RT130 3.4.3 Firmware Update - PASSCAL User Notes

Eric Makarewicz and Brit O'Neill, 2013-05-07

In this document are listed the firmware changes between version 3.0.0 and 3.4.3, from the Reftek 130-CPU Firmware Release Notes, along with comments on how usage or results are different for some of the changes.

3.4.0-2. Correction to the EH/ET Packets Full Scale Analog Code

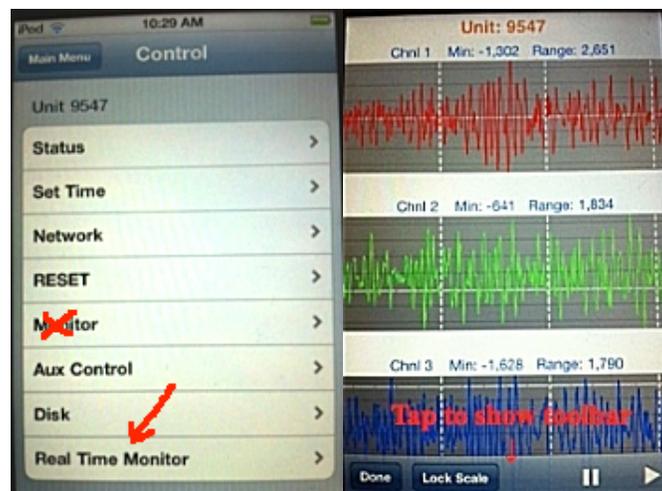
The firmware has been changed to add a code to allow a +/-20 V full scale analog sensor to be specified in the EH/ET packets.

3.4.0-8. Addition of Automatic Mass Re-centering

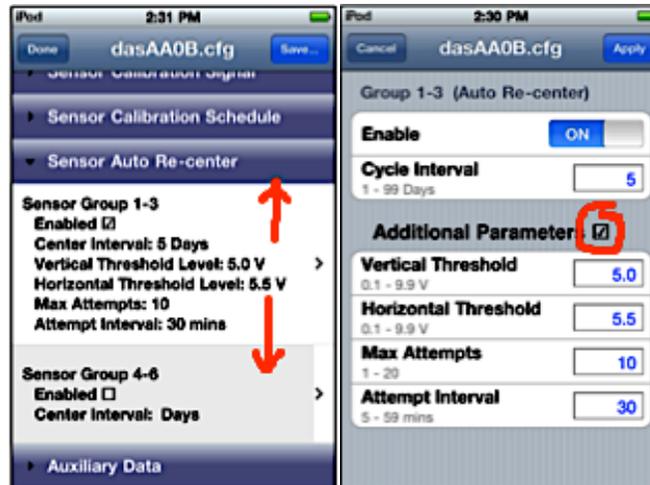
The existing "PQ" command has been expanded to provide greater control of the re-centering of the mass of a sensor.

Previously users have been able to "auto center" sensors, having the RT130 automatically send a centering command at specified intervals. With this firmware update, and using iFSC (iPod or iPhone app), there is now the option to set mass position thresholds for sensor centering. These options are accessed through the menus for editing a configuration. On the main Edit Configuration page in iFSC, to view the Sensor Auto Re-center parameters that have been set, use the "pinch-out" gesture (see below) to expand the display area. After enabling auto re-centering, tap the right hand arrow to get the edit screen and then tap the "Additional Parameters" checkbox:

3.4.3-5. Modification to Include 50 SPS as Part of Group Two

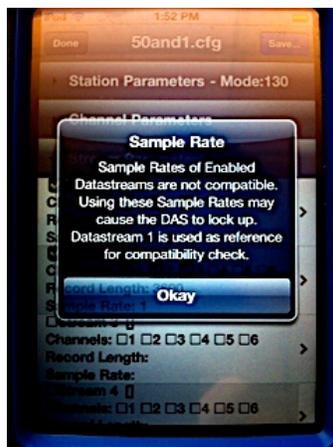
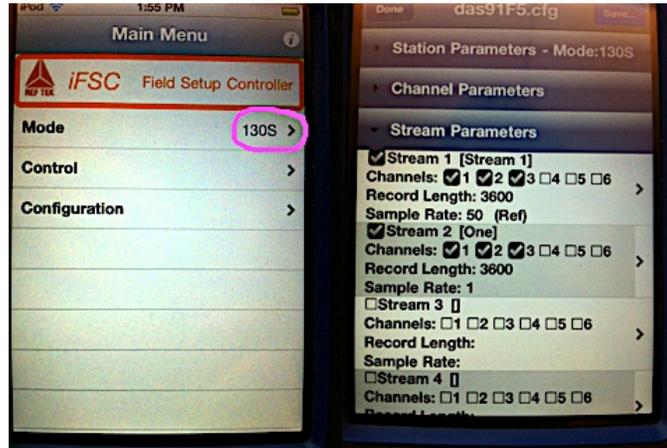
The code has been modified to move 50 sps from Group One to Group Two. This change will allow the user to record a stream at 50 sps and additional streams at any other Group Two rate simultaneously.

If you try to program a PASSCAL RT-130 for this option (i.e. using 50 sps with another sample rate) using iFSC in the 130 mode, it will either not allow you to chose mismatched data streams or it will give an error like this:

However, if you switch to the 130S mode, then you can configure the RT130 with mixed data streams that include 50sps:

3.2.2-5. Modification to the Disk LED Illumination during Boot-up

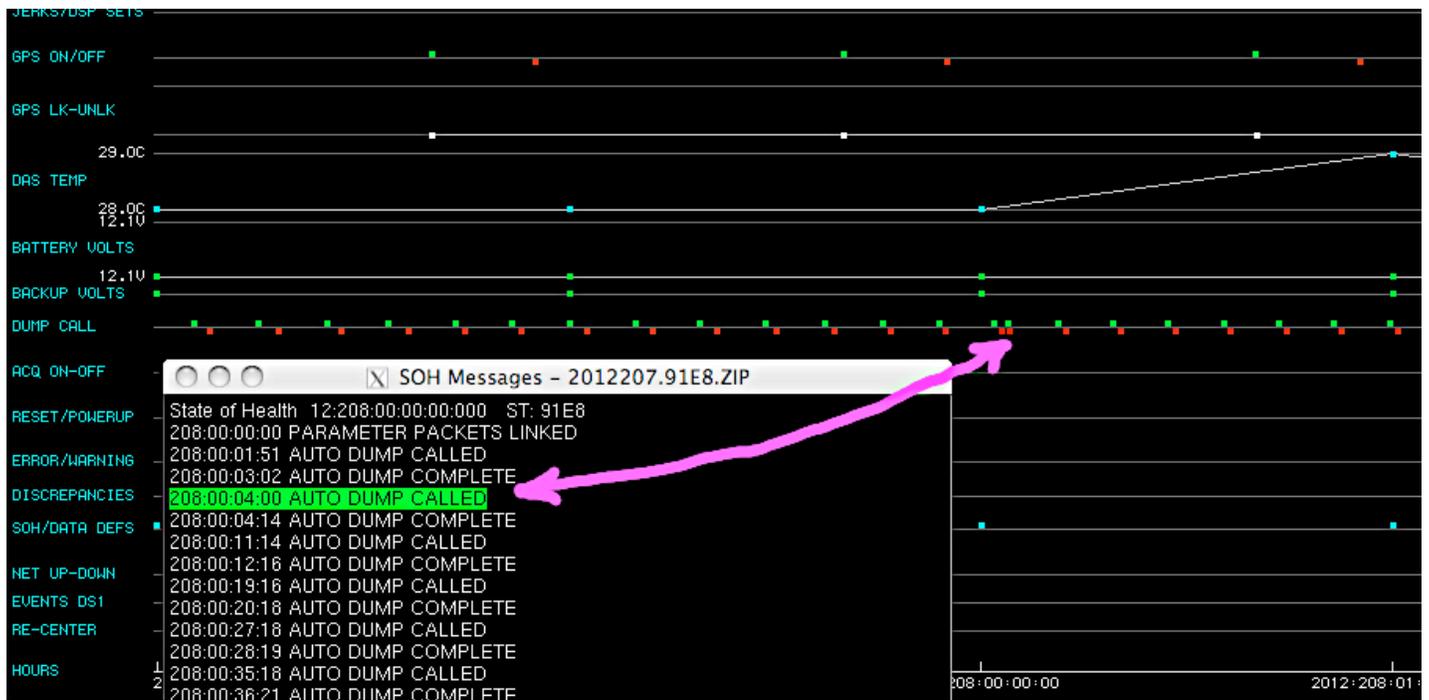
3.4.3 firmware, on startup, initially lights both disk RED LEDs simultaneously for 4-5 seconds, then briefly both GREEN LEDs light, followed by a short RED-GREEN sequence on one disk and then the other, then both GREEN.

3.0.0 firmware, on startup treats disks sequentially, with the RED LED for 1 second, followed by GREEN LED for 1-2 seconds, then RED LED for 3 seconds or until the first disk fully read, then the same sequence on the second disk.

The main point is to not remove either disk until the unit is fully booted up.

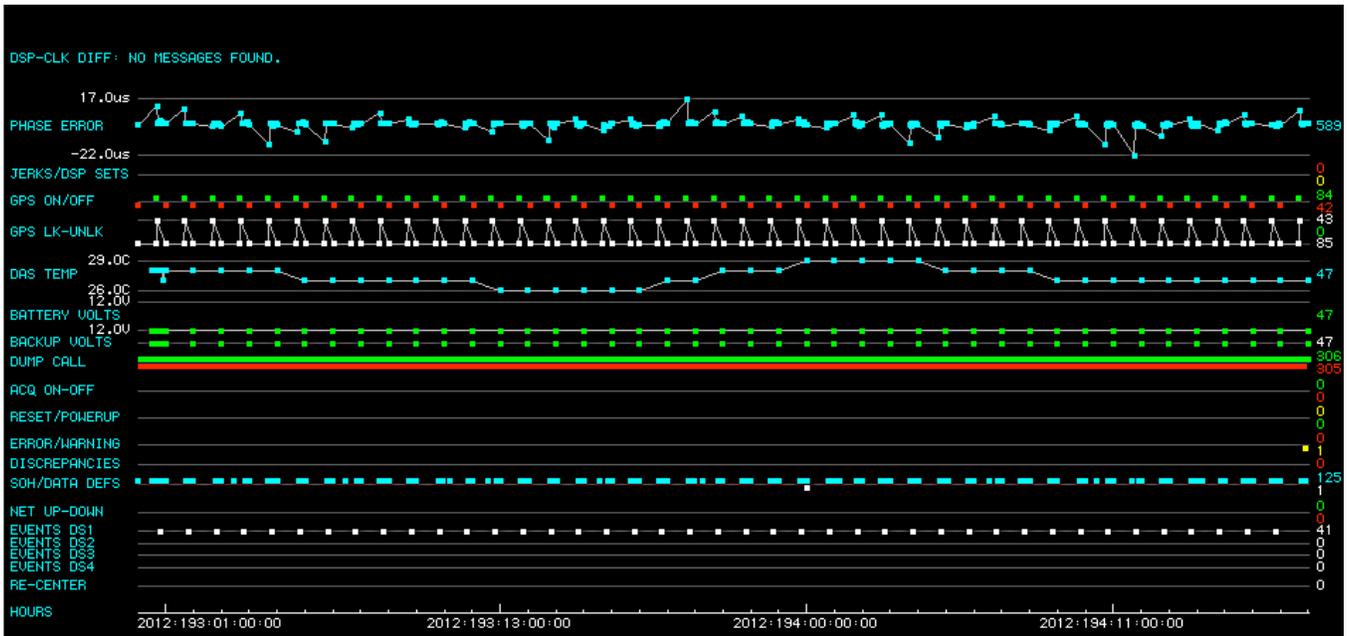
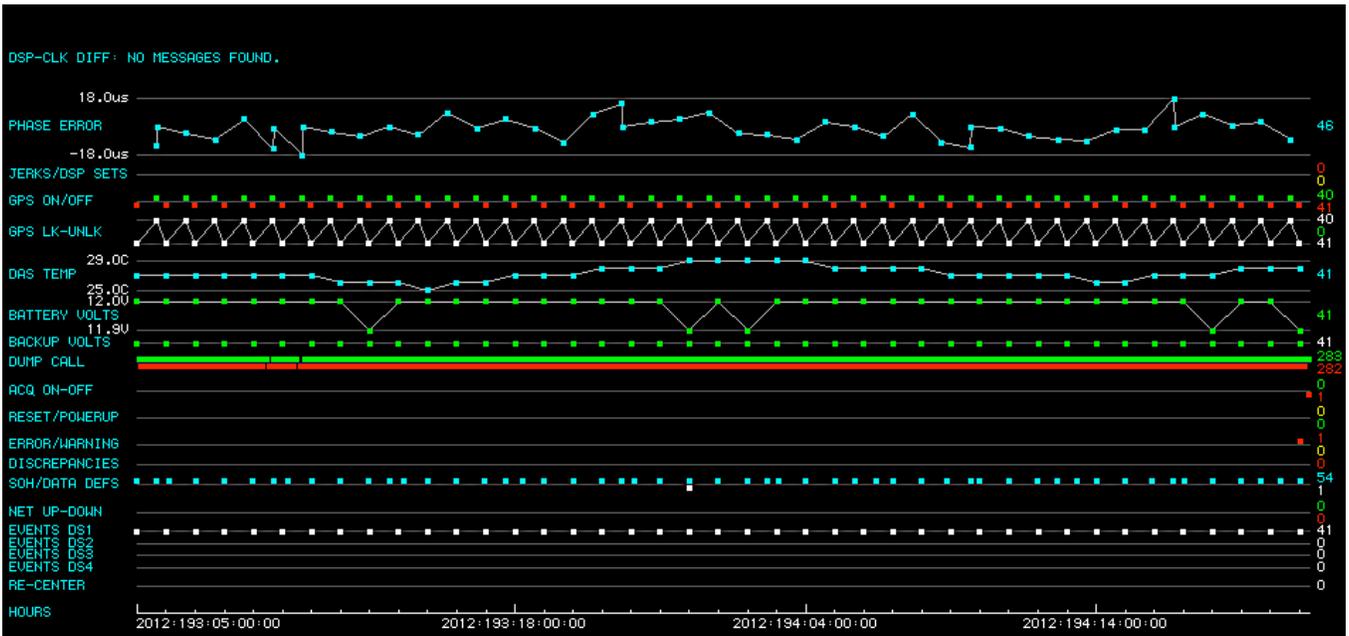
The difference in the Phase Error message output is seen dramatically in logpeek. The first logpeek screen

below is from 3.0.0FW while the second screen capture is from a DAS with 3.4.3FW. Note the significantly different pattern in the phase error traces:

Another point of interest that is illustrated in the two logpeek screen captures above is the additional difference in the GPS LK-UNLK traces. The difference can be seen in the SOH log text examples above as well. In the 3.0.0 example at the start of the clock cycle, the first poll of the clock finds it's status unlocked and then in the second poll 15 seconds later the clock is locked. Finding the clock initially unlocked generates the sawtooth LK-UNLK trace in the upper screen capture. On the 3.4.3 example, the initial poll of the GPS finds it locked,

3.3.0-1. Modification to CLK Phase Error Correction when GPS Lock is Lost

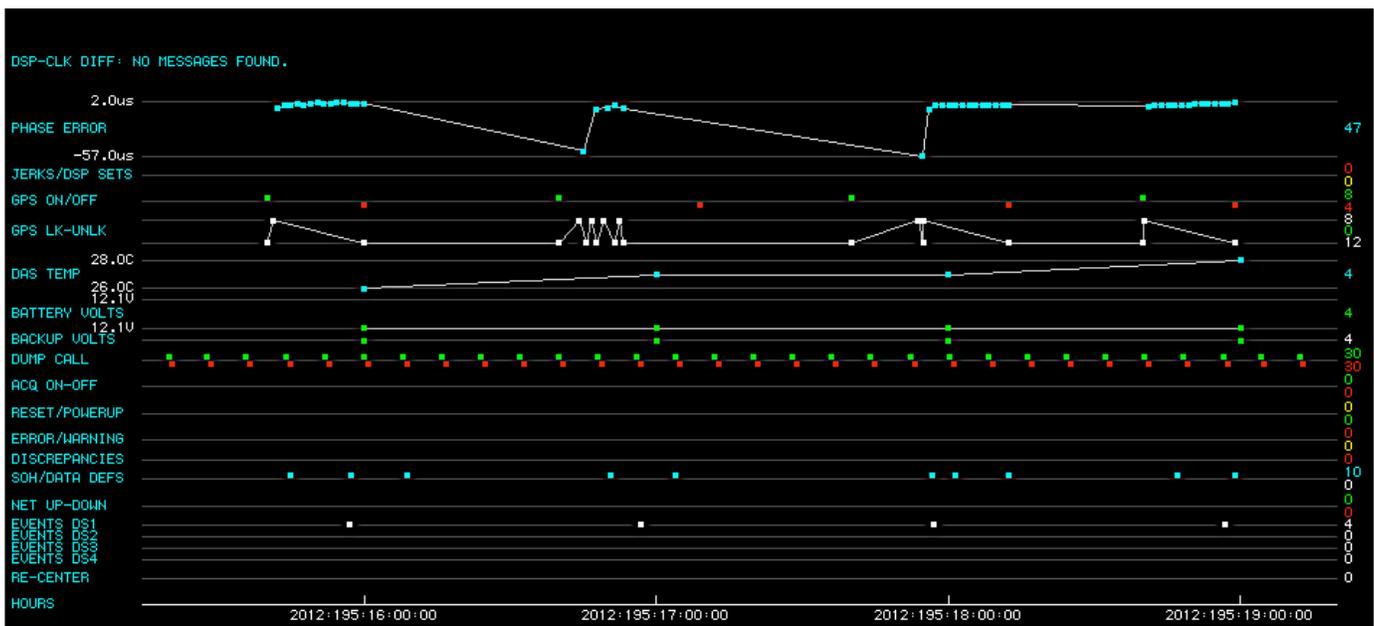
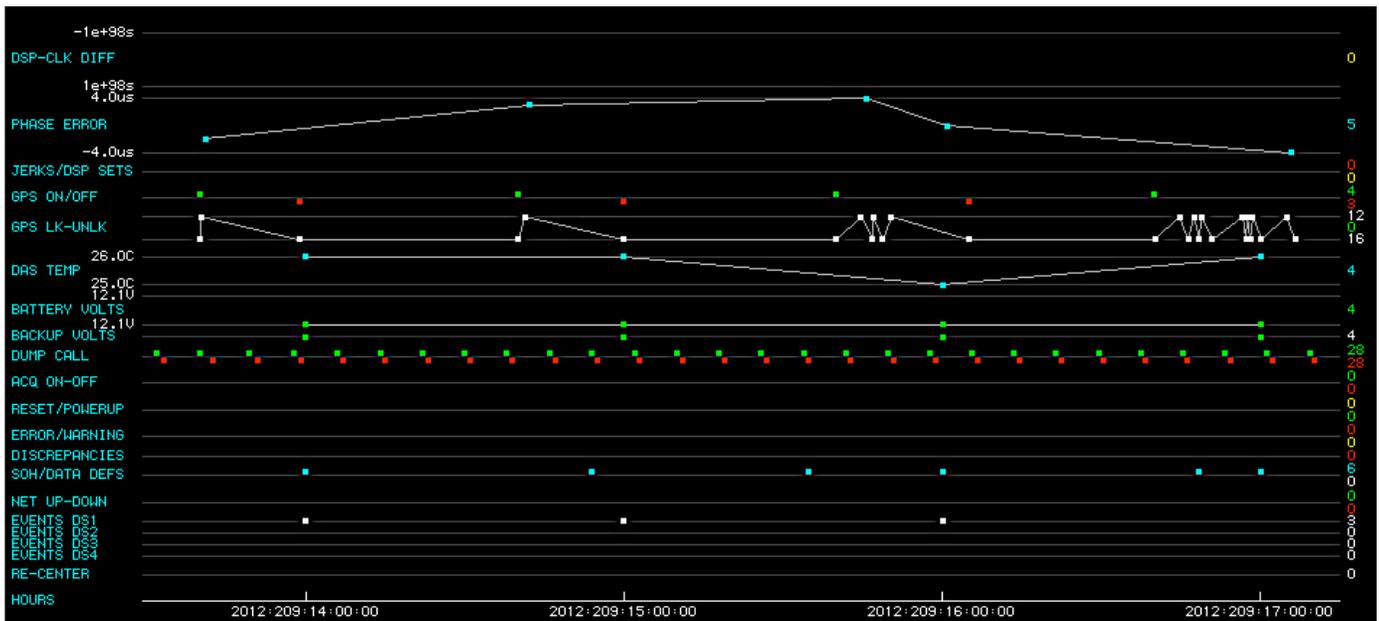
With 3.0.0 firmware, during the GPS power On cycle, when the lock was lost during phase error calculations, larger errors could be calculated. In the logpeek capture below, the lock was lost near the start of two GPS cycles (as seen in the GPS LK-UNLK trace) and >50 μ second errors were calculated (shown in the light blue PHASE ERROR trace). This is also detailed, and highlighted, in the log messages below the screen capture:

With 3.4.3, when the GPS lock was lost during phase error calculations, drift corrections were suspended. The logpeek screen capture below shows a similar example to that above, of the GPS lock being lost, but the suspension of drift corrections prevents the larger phase errors (the scale on the Phase Error trace is +4.0 to -4.0 μ seconds). The log messages for this example, showing the suspension of drift correction, are listed below the screen capture:

3.2.2-8. Modification to the LP and WP, Data Moved from Disk to SPROMS

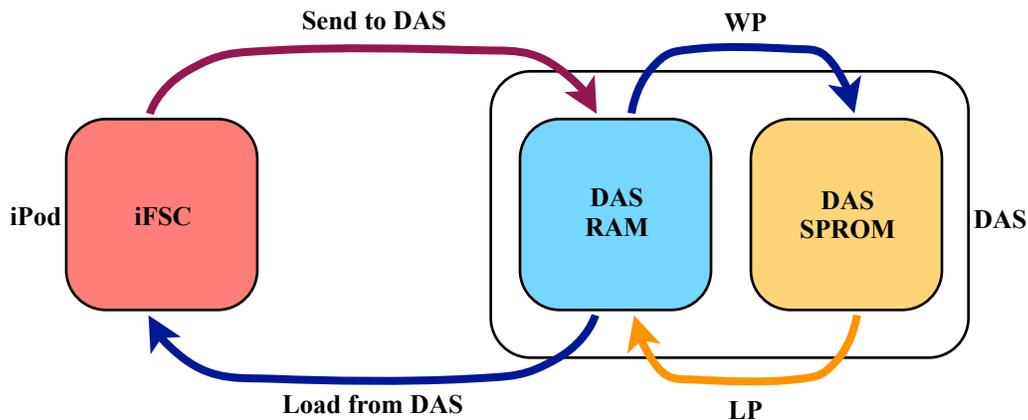
The following illustration shows the path of configuration parameters when using the "Send to DAS", "Load from DAS", "WP" and "LP" commands:
